WSDOT Design Manual Chapter Revision

Subj: Design Manual Chapter Revision Review

Chapter Title: 1320 – Roundabouts

Reason for Revision: To reduce PE efforts related to roundabout analysis, documentation, and approvals. Additional change calls for using the WB-67 design vehicle for roundabout design on state routes and updating capacity analysis software.

Entry Angle
Exhibit 1320-2

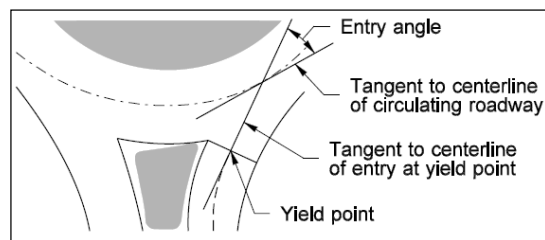
Comment [KS24]: Need to update this exhibit Show the splitter islands, ped crossings, revise departure to exit

Comment [JT25]: No use. Recommend deleting....

[The only purpose for this drawing is to identify elements that are defined.]

Mini Roundabout*Exhibit 1320-4***(2) Single-Lane Roundabouts**

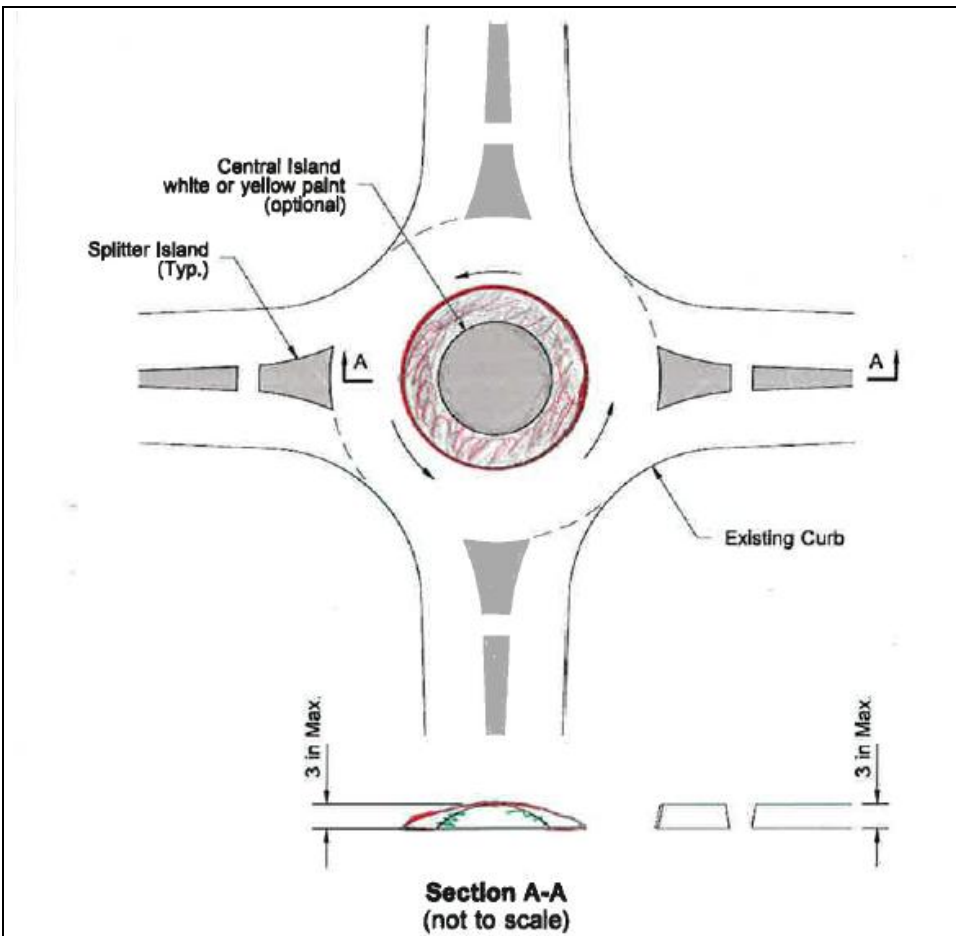
Comment [KS31]:
 Section A-A needs work:
 Crosswalks, sidewalks, etc
 Also see John Tevis's
 drawing
 [For a "not-to-scale"
 cartoon, I don't believe that
 the changes are needed.]

Single-Lane Roundabout
Exhibit 1320-5

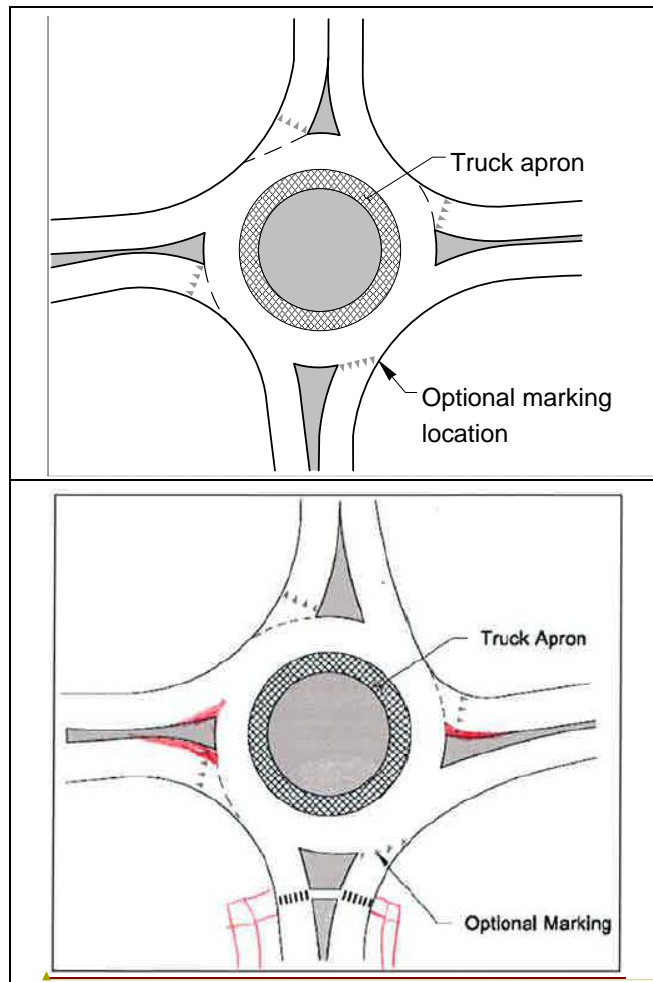
Comment [KS32]: Left & Right leg entry is not drawn correctly
 [Exhibit redrawn, crosswalk removed]

Multilane Roundabout
Exhibit 1320-6a

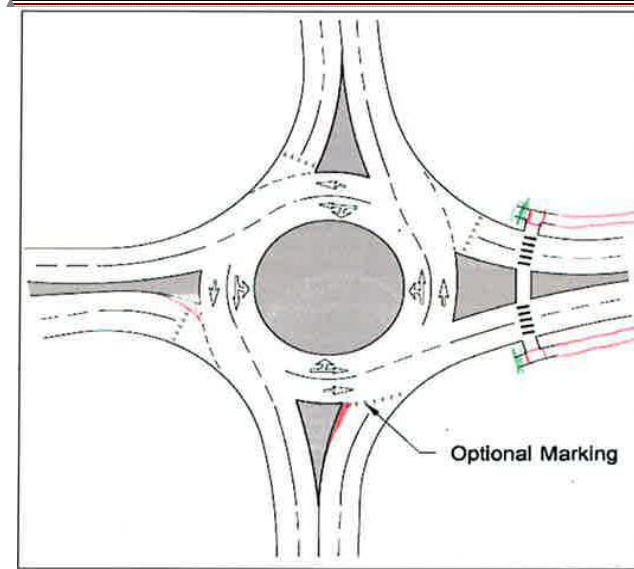
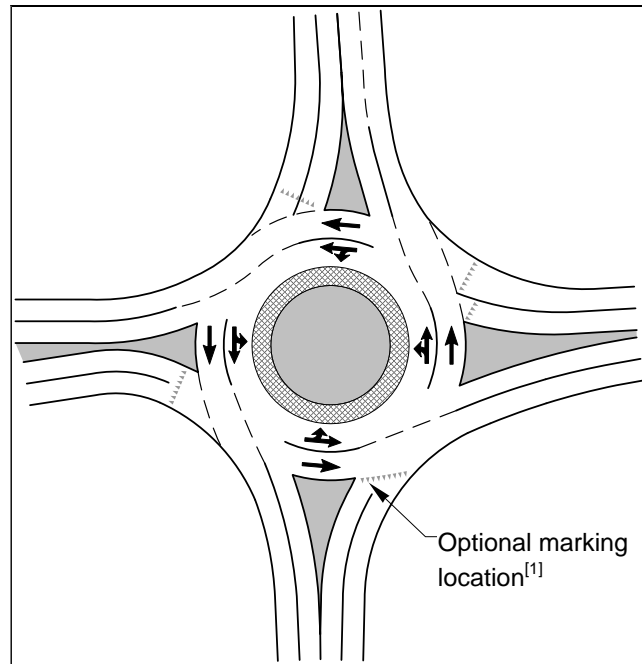
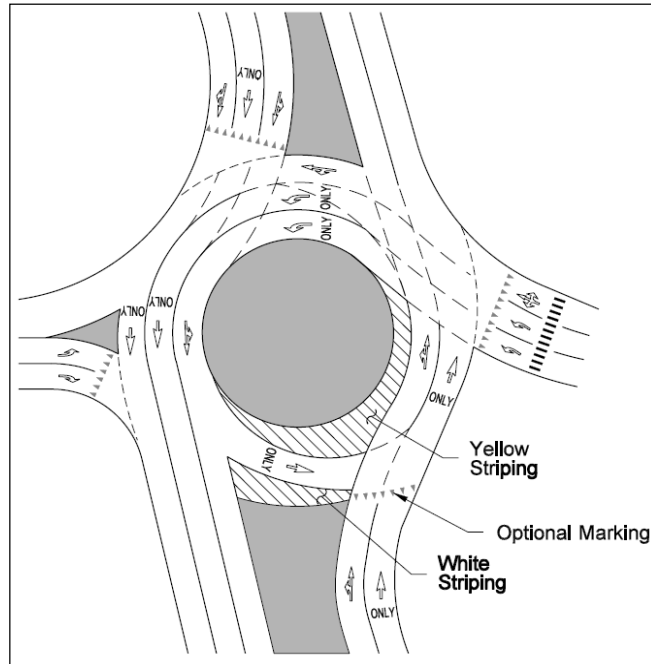
Comment [TWF33]:
Remove all crosswalks and
pedestrian facilities.

Comment [KS34]: See John Tevis's drawing. Also make a note that pedestrian and bike ramps and connections

Teardrop Roundabout at a Ramp Terminal
Exhibit 1320-7a

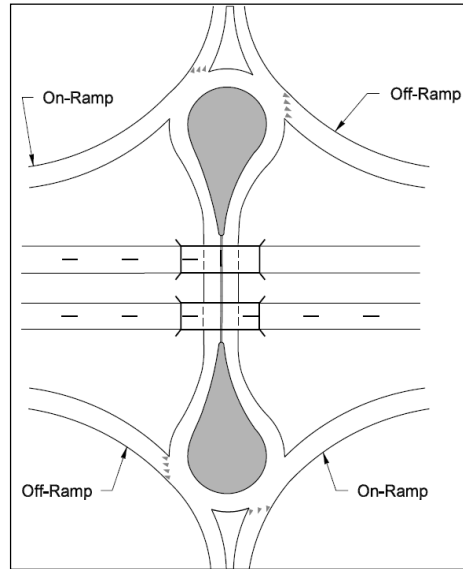
Comment [KS35]:
Missing the lane stripe in the upper roadway

Teardrop Roundabout and a Multilane Roundabout with Spiral Striping With Ramps
Exhibit 1320-7c

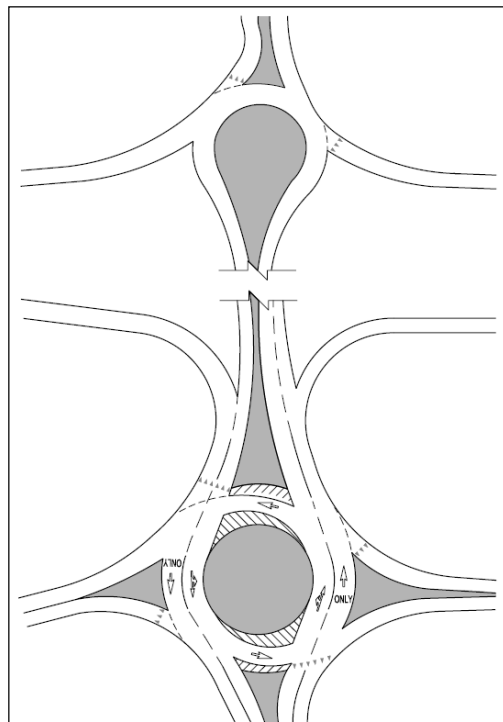
Comment [KS37]: This drawing needs to be worked on. Should the freeway be shown?

Approach Stopping Sight Distance to Crosswalk
Exhibit 1320-21

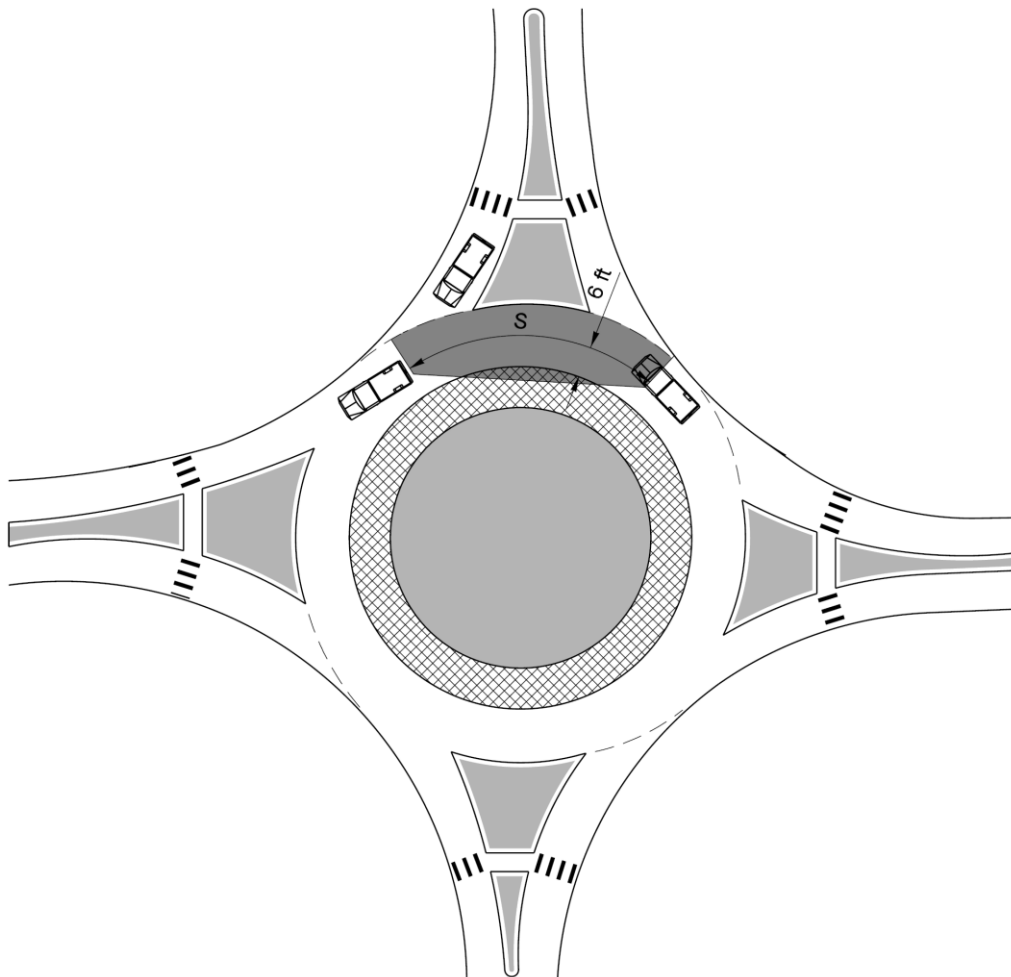
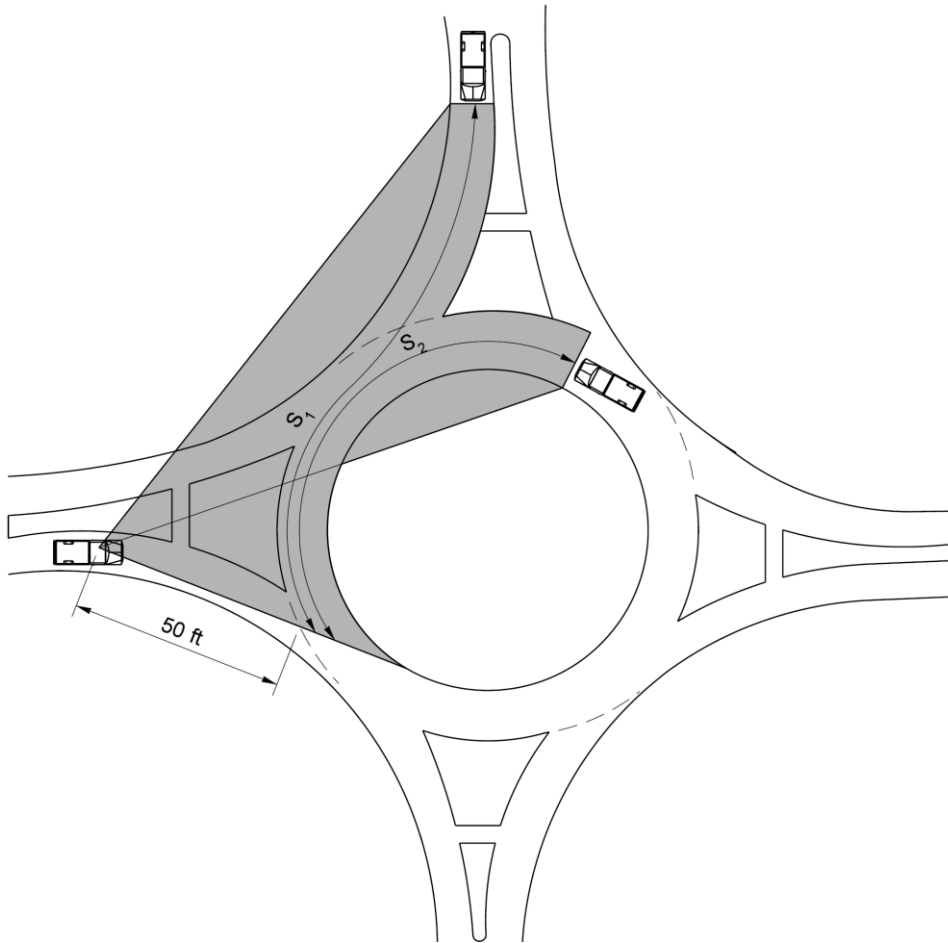
Well anyway Exhibits 1320-23 and 1320-21 are different and one or the other needs to be changed.

Exhibit 1320-23 is closer to correct than 1320-21. Chapter 1310 specifies that the sight distance be provided to the crosswalk and 6 ft from the edge of traveled way. See 1310.05(6).

Comment [TWF1]:
Revise drawings 21 & 23.
Area covered should be similar, car in 23 should be in roundabout.

Comment [TWF6]: A version of this can replace both 21 & 23

For consistency with Ch 1310 the following should be added to 1320.06(3)(h):

"Provide drivers approaching crosswalks decision sight distance to an area the width of the crosswalk and 6 feet from the edge of traveled way. Where decision sight distance is not feasible, stopping sight distance may be provided. (See Chapter 1260 for guidance on decision and stopping sight distances.)"

Intersection Sight Distance
 Exhibit 1320-24

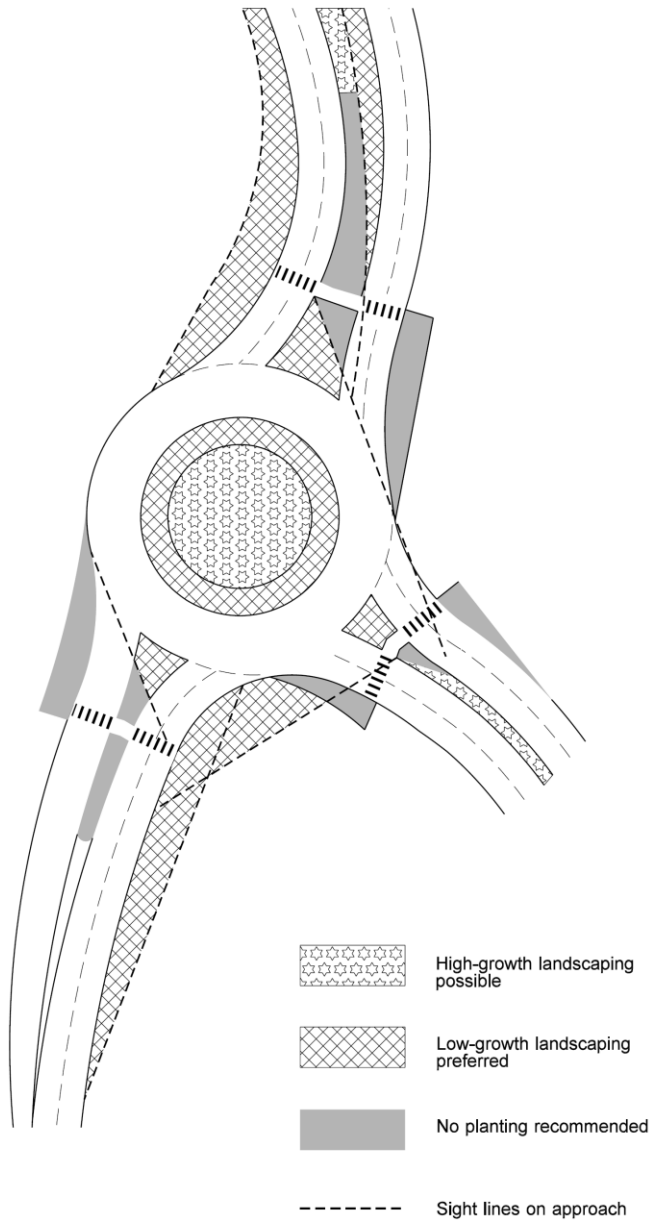
Comment [TWF68]: (WS DOT?) for Passenger Vehicles (Consider ability to see opposing entry for locations with significant Truck and Recreational Vehicle percentages)

Exhibit 1320-27

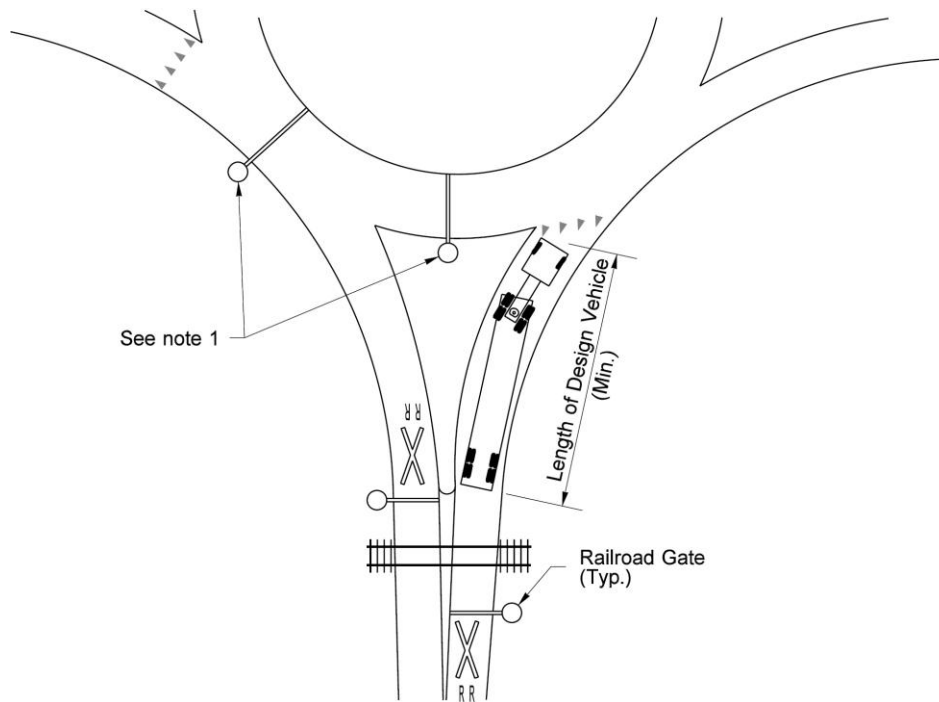
Comment [PR69]:
 (Consider using Exhibits 1310-12a, 1310-12b, and 1310-7 for determining minimum storage lengths when significant truck percentages are present. My concern is that 100-ft min may be too short for equal lane utilization)

Bicycle Lanes
Exhibit 1320-29

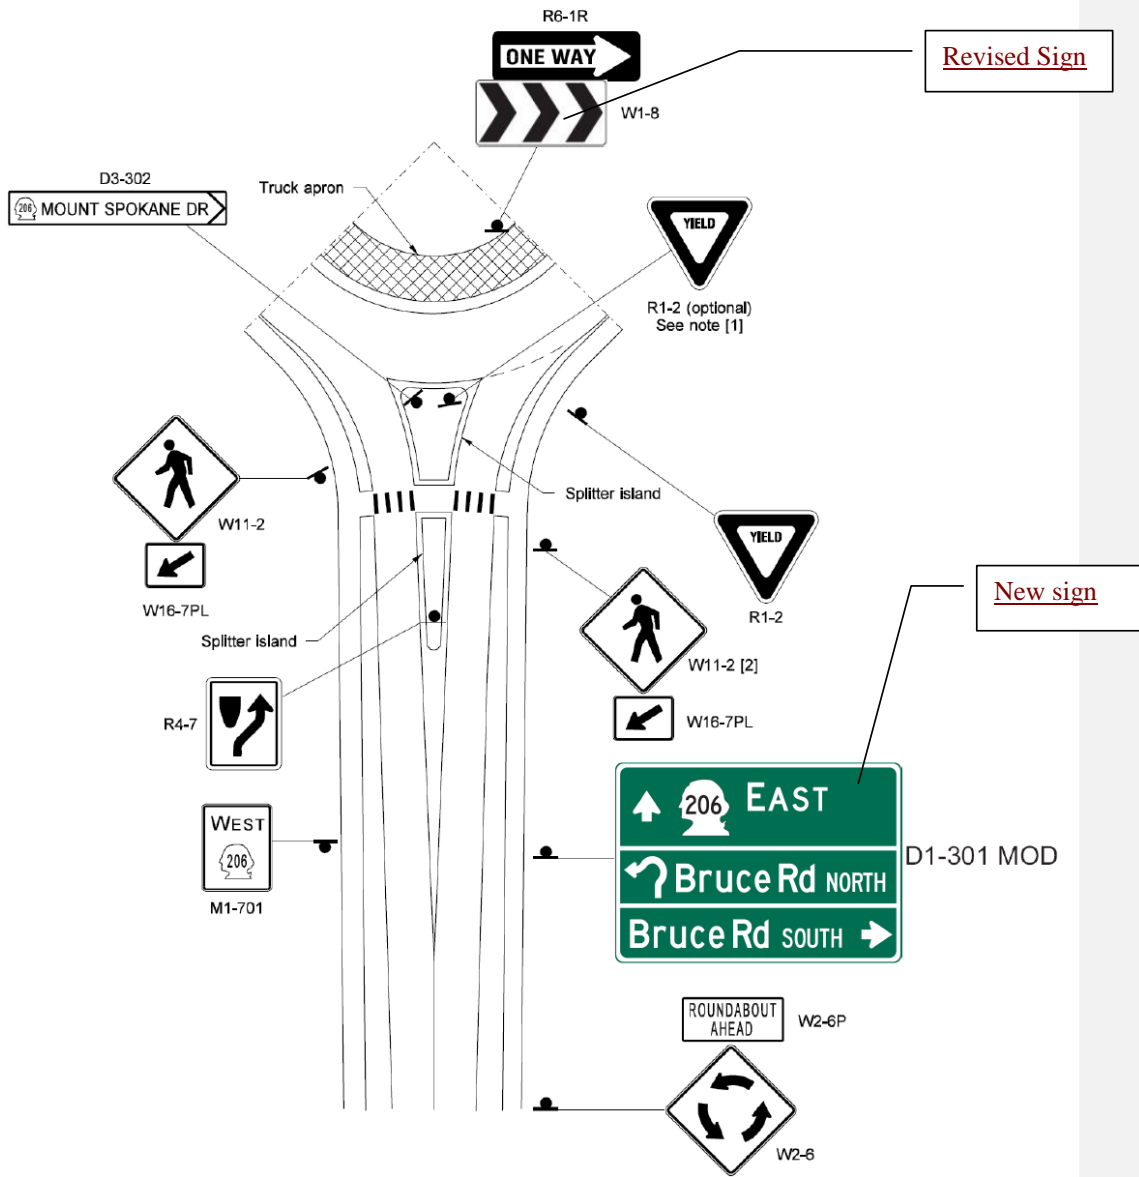
- The image showing bike lanes coming into a roundabout needs clarification (p. 1320-45). As is, the drawing indicates that bike lanes should be striped right to the ramp, indicating that cyclists should use the sidewalk. As cyclists have a choice, a dashed bike lane stripe may be more appropriate coming into the roundabout so a bicyclist can decide whether to move into the general travel lane or go onto the sidewalk.

Roundabout Striping and Pavement Marking
Exhibit 1320-31

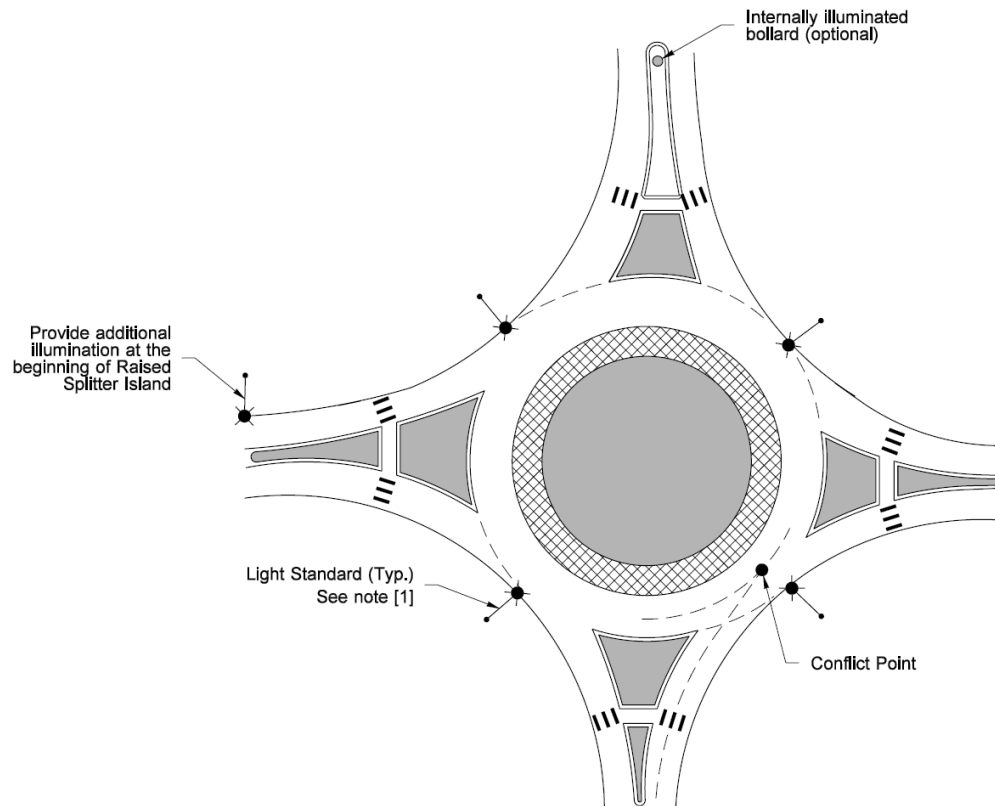
Comment [TWF11]: As a Standard Plan, this is OK. For the *Design Manual*, the only change should be to the multilane example exhibits. Other striping exhibits should be removed and replaced with references to the MUTCD, *Traffic Manual*, and *Standard Plans*.

Comment [KS70]: What is Ed Laugergin's recommendations?

Roundabout Illumination
Exhibit 1320-32

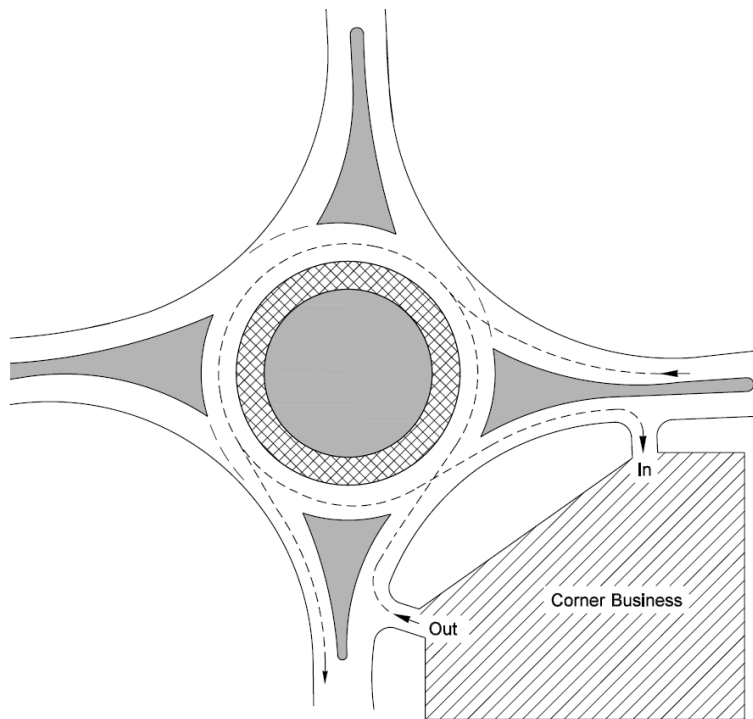
Comment [ORTraffic71]:
Refer reader to the
illumination section in the
design manual?

Multiple Access Circulation
Exhibit 1320-33a

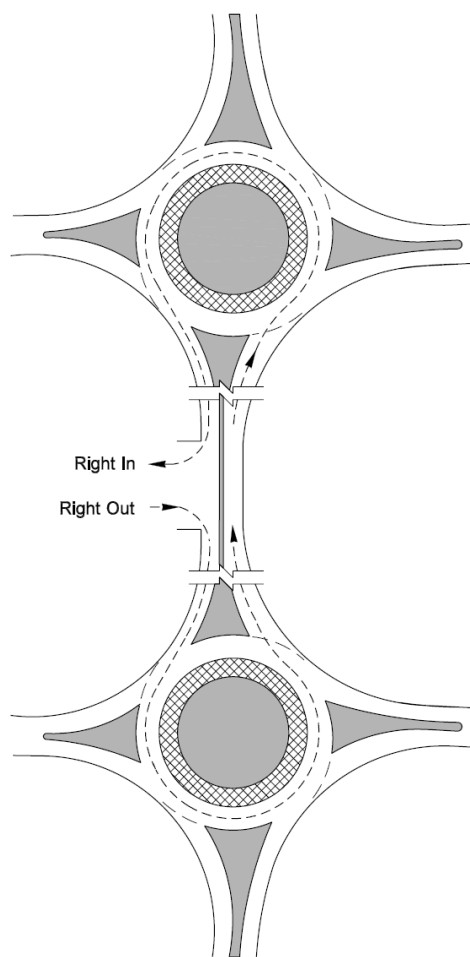
Comment [W72]: Show right-in movement on bottom access and right-out movement on top access
